Internal Memo

Planning Application No-190292-Cyfarthfa Park Lodge bungalow, Queens Road, Twynrodyn, Merthyr Tydfil.

Proposal: Dormer conversion comprising an increase in roof ridge height with front and side dormers, introduction of a Juliette balcony and construction of a front conservatory

O.S. Map 1963

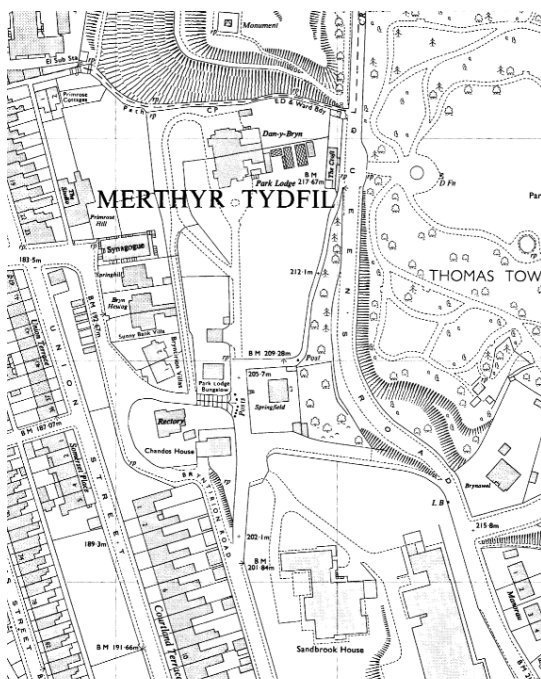
The 1963 O.S. plan show that the original lodge has been added too to the northern side and the roof structure has been altered showing a slightly flared roof shape.
